One Victoria,

Great Ducie Street,
Manchester

Proposed Amendments

Comparative Drawing Study

Car Park Layout - Hodder + Partners Proposal

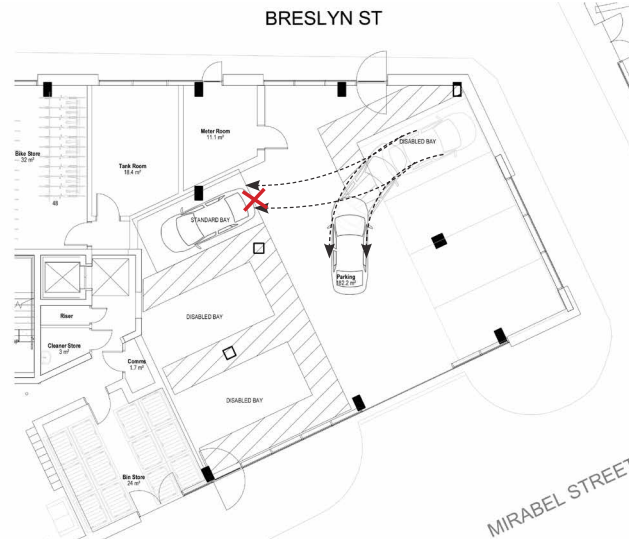
The approved layout doesn't comply with Approved Document M where a 1200mm zone is required either side of every parking space

Car Park Layout - DAY Interim Design

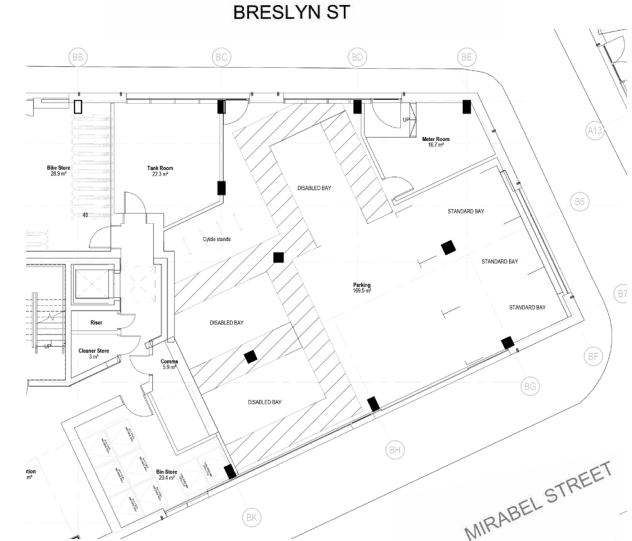
Updated proposal to maintain 3no. disabled bays and provide the 1200mm zone to both sides of 2no disabled bays. This layout was tracked and isn't acceptable, if a car is parked in the top left bay, the vehicle in the top right bay cannot reverse out.

Updated to maintain 3no. disabled bays with the relevant 1200mm clear zones as per Approved Document M. This layout also allows vehicles to manoeuvre in and out whilst fully occupied. Meter room relocated to the other side of the car park.

Ground Floor Plan - DAY Amendment

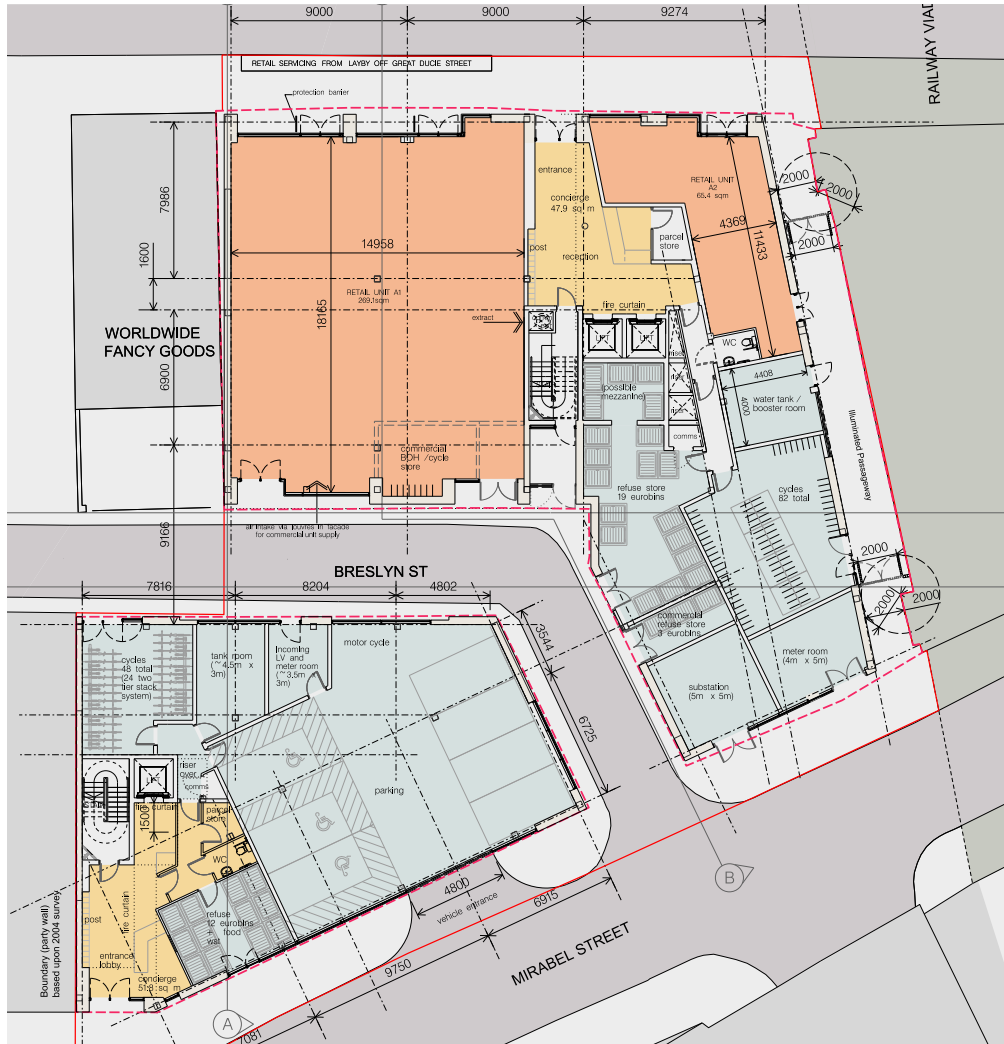
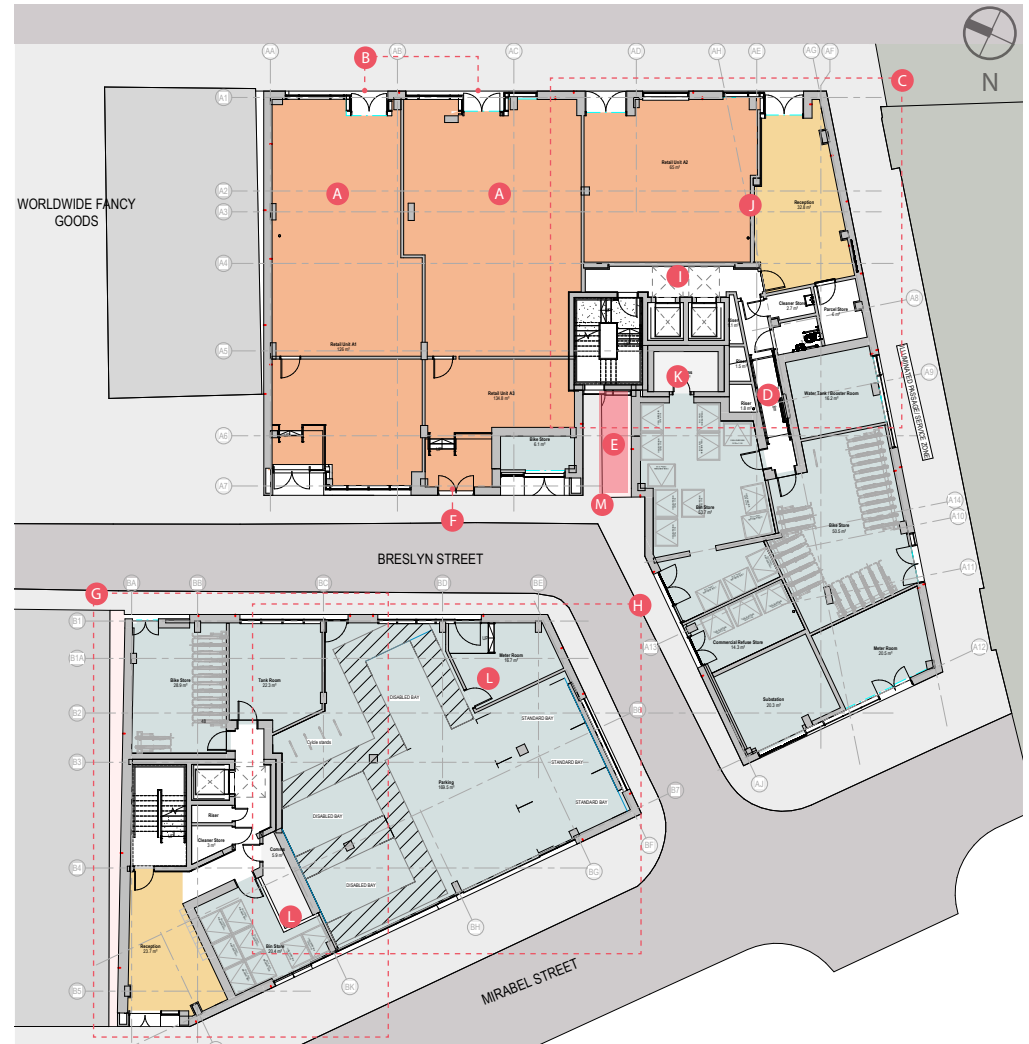
- A Retail Units split into 2no. units
- B Recessed shop fronts to be omitted in favour of smaller reveal
- C Retail unit swapped with reception - preferred from fire and structural view. Parcel store relocated. Cleaner's store included. Core updated due to no-build area
- D Ramp added to provide access to bin store
- E No build zone shown hatched
- F Additional door included
- G Updated layout following exclusion of no-build zone and structural core / riser cleaners store/ removal of WC as not required
- H Layout amended to maintain 3no. disabled spaces along with 3no. standard spaces due to space constraints and following vehicle tracking exercise.
- I Protected escape route added in line with building regulation requirements.
- J Entrance lobby and retail space location switched.
- K Comms rooms added
- L Meter room added
- M Secondary gate omitted to no-build zone

1st-2nd Floor Plan - DAY Amendment

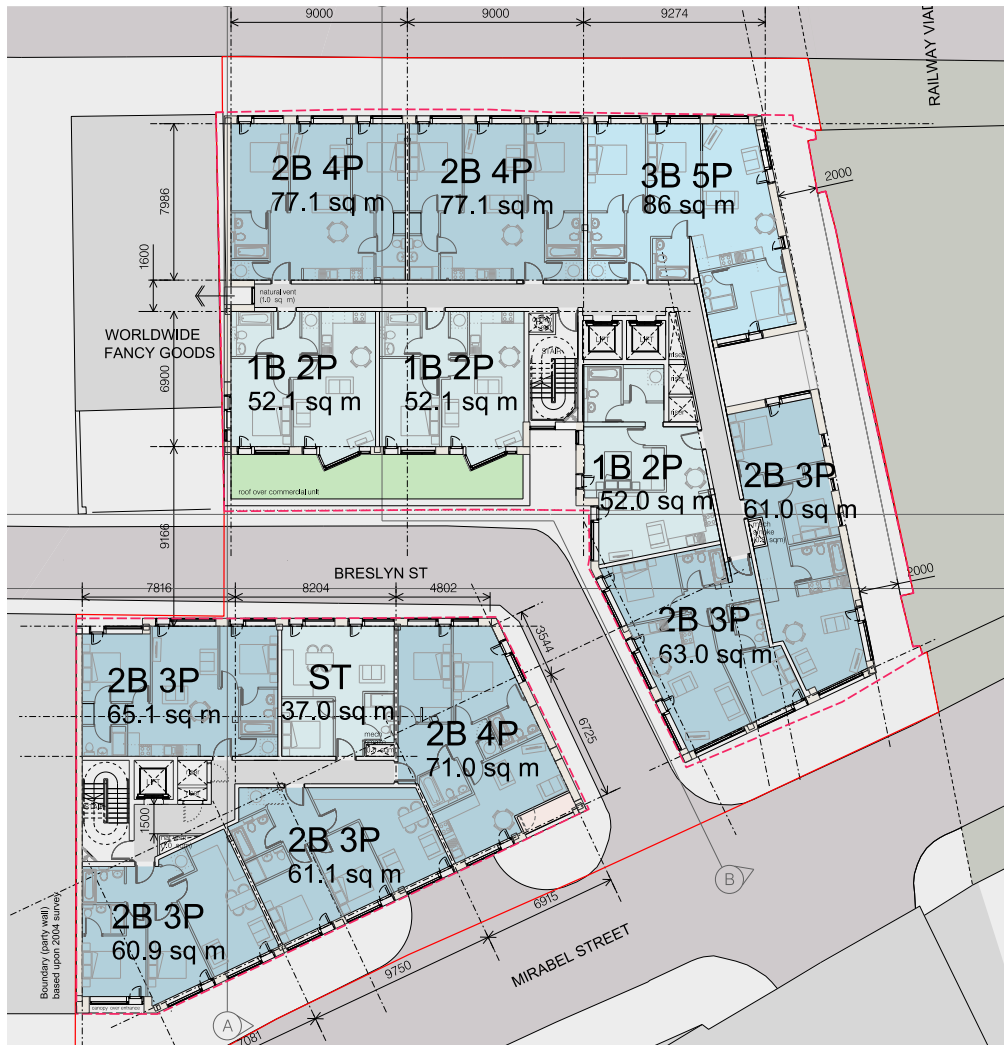
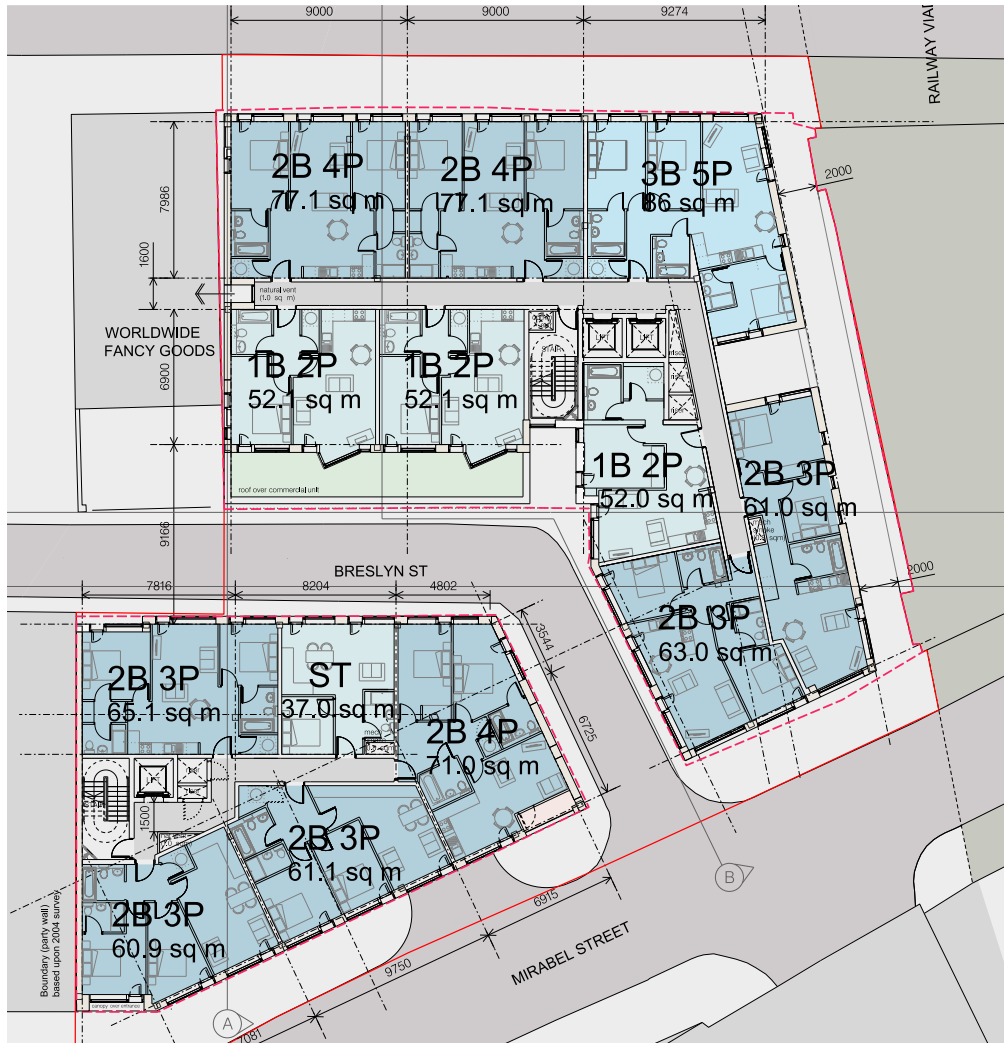
- A Layouts updated to remove wardrobes whilst ensuring the storage meets space standards
- B Width of split in facade reduced to 685mm (from 900mm) to align with brick dimensions
- C Window to the gable end updated to allow a maximum unprotected area of 1m sq in line with fire regulations
- D Updated layout following exclusion of no-build zone and structural core / riser
- E Layout flipped to reduce escape distances
- F Core updated due to no-build zone
- G Additional riser provided as storage for apartment
- H Apartment layout updated to include store / service cupboard
- I Layout updated to remove lobby and increase living space
- J Window adjacent to bay now becomes a full height openable window unit with a dummy transom (for continuity)

3rd-4th Floor Plan - DAY Amendment

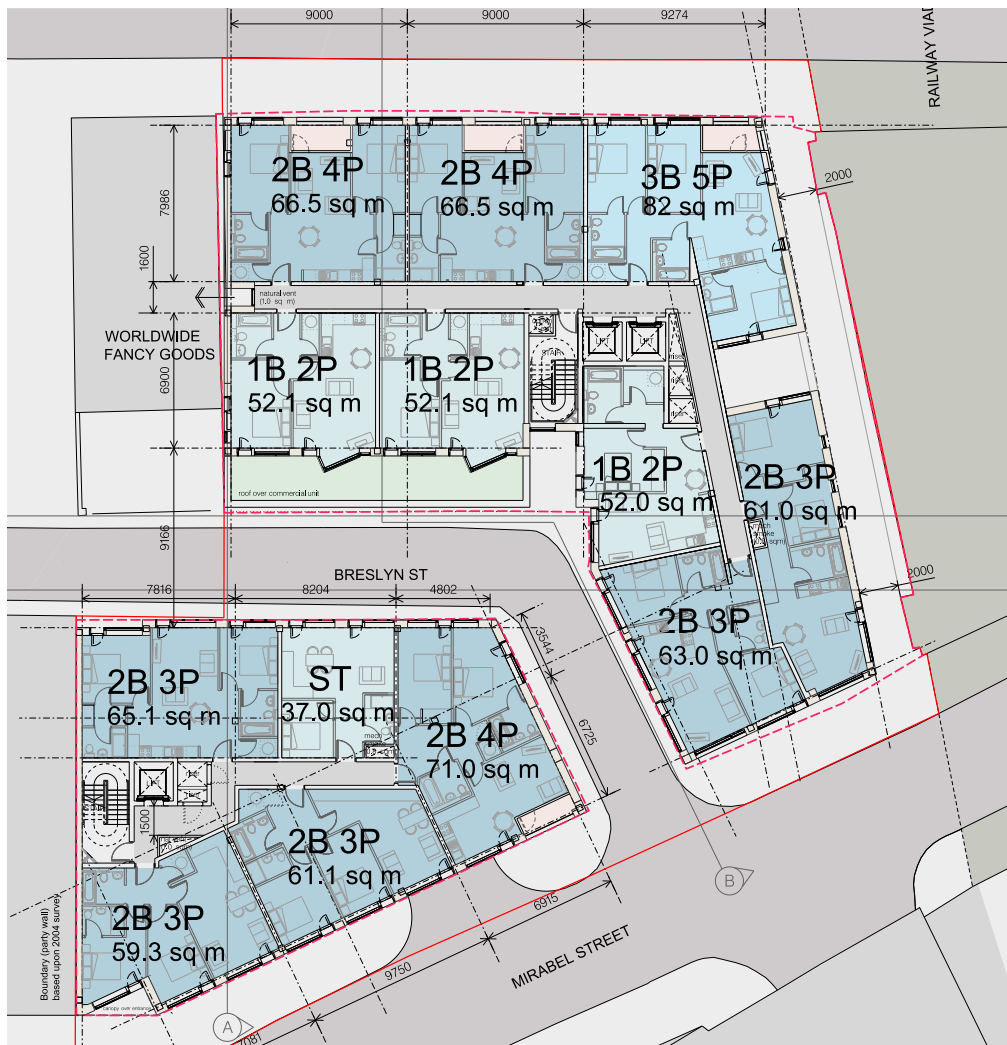
- A Layouts updated to remove wardrobes whilst ensuring the storage meets space standards.
- B Width of split in facade reduced to 685mm (from 900mm) to align with brick dimensions
- C Window to the gable end updated to allow a maximum unprotected area of 1m sq in line with fire regulations
- D Updated layout following exclusion of no-build zone and structural core / riser
- E Layout flipped to reduce escape distances
- F Core updated due to no-build zone
- G Additional riser provided as storage for apartment.
- H Apartment layout updated to include store / service cupboard
- I Layout updated to remove lobby and increase living space
- J Window adjacent to bay now becomes a full height openable window unit with a dummy transom (for continuity)

5th-9th Floor Plan - DAY Amendment

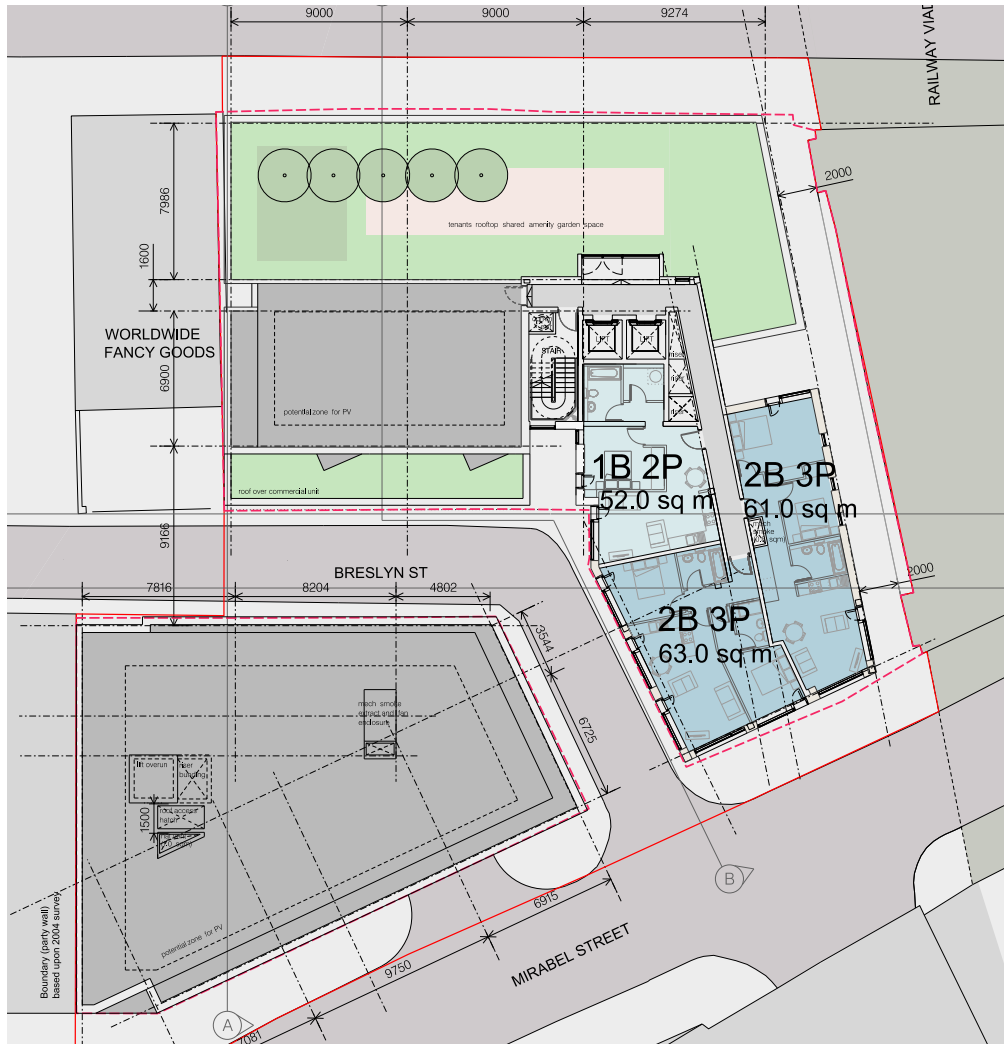
- A Layouts updated to remove wardrobes whilst ensuring the storage meets space standards.
- B Width of split in facade reduced to 685mm (from 900mm) to align with brick dimensions
- C Window to the gable end updated to allow a maximum unprotected area of 1m sq in line with fire regulations
- D Updated layout following exclusion of no-build zone and structural core / riser
- E Layout flipped to reduce escape distances
- F Core updated due to no-build zone
- G Additional riser provided as storage for apartment.
- H Apartment layout updated to include store / service cupboard
- I Layout updated to remove lobby and increase living space
- J Window adjacent to bay now becomes a full height openable window unit with a dummy transom (for continuity)

10th Floor Plan - DAY Amendment

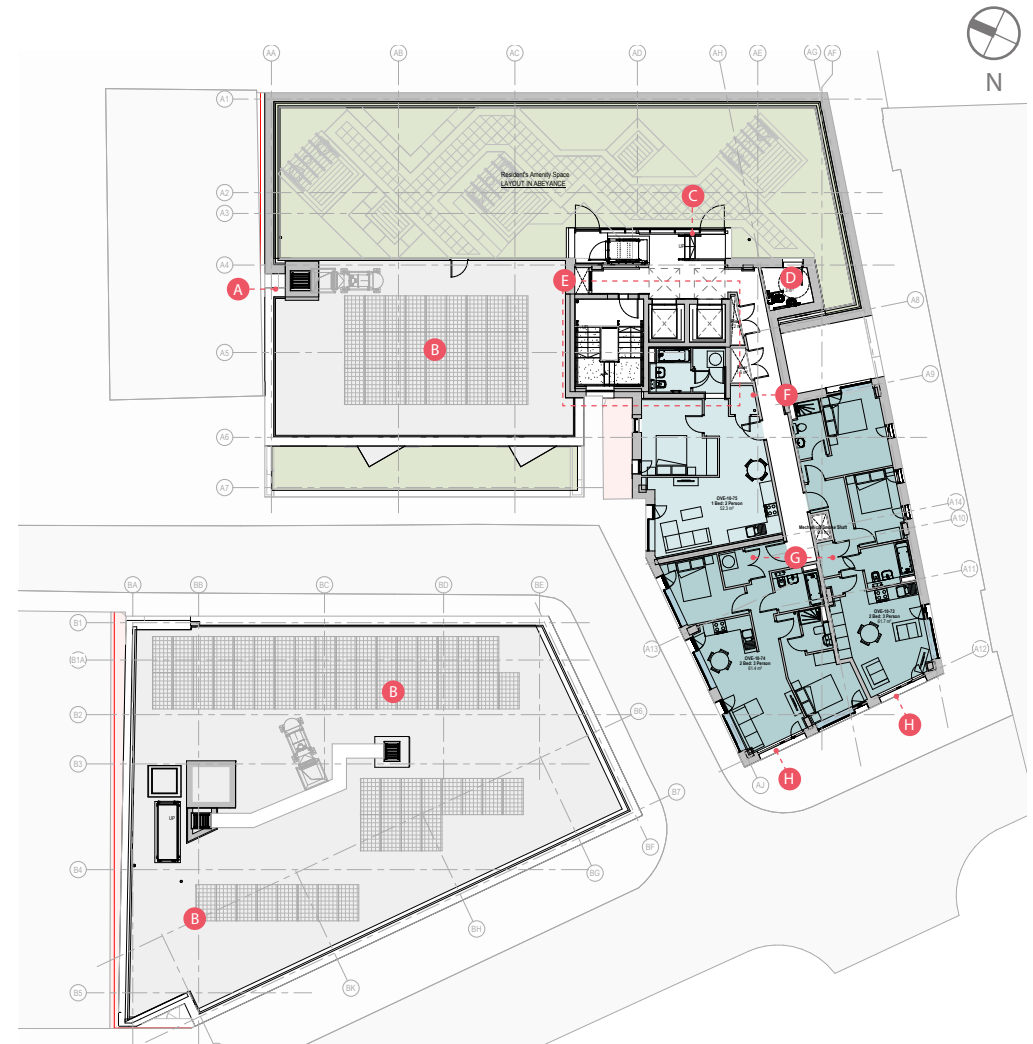
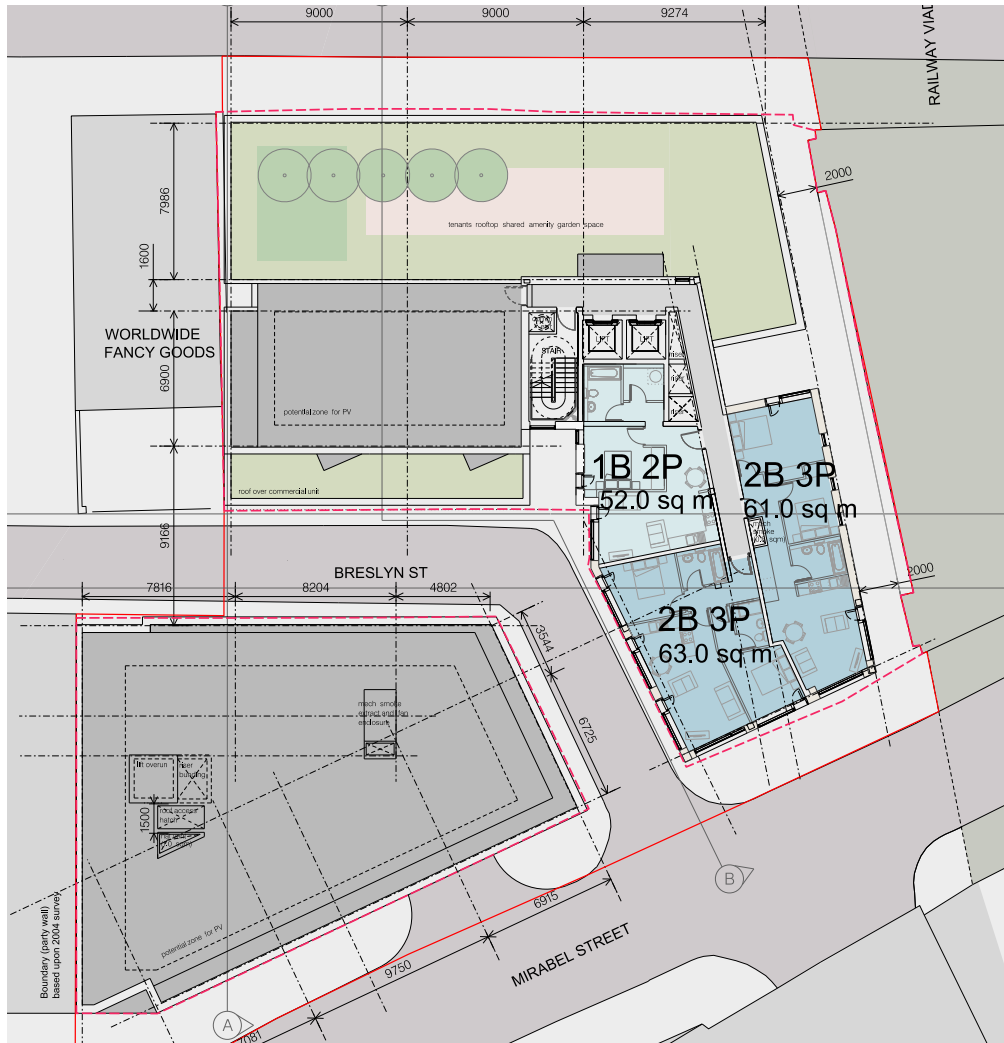
- A Width of split in facade reduced to 685mm (from 900mm) to align with brick dimensions
- B Roof plant shown
- C Feature surround to amenity space curtain walling increased in depth to allow for accessible ramp
- D External accessible WC included for amenity space users
- E Core updated due to no-build zone
- F Additional riser provided as storage for apartment.
- G Apartment layout updated to include store / service cupboard
- H Window adjacent to bay now becomes a full height openable window unit with a dummy transom (for continuity)

11th-12th Floor Plan - DAY Amendment

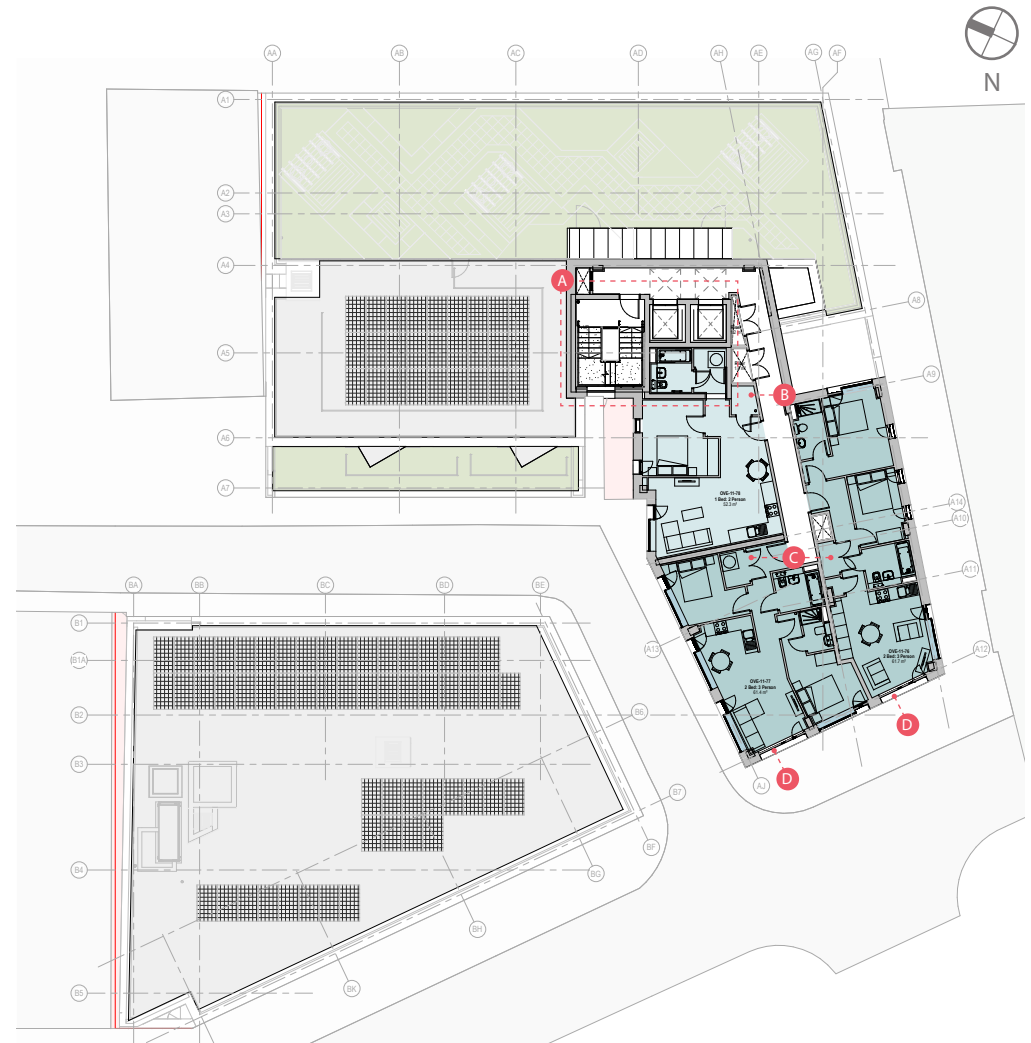
- A Core updated due to no-build zone
- B Additional riser provided as storage for apartment.
- C Apartment layout updated to include store / service cupboard
- D Window adjacent to bay now becomes a full height openable window unit with a dummy transom (for continuity)
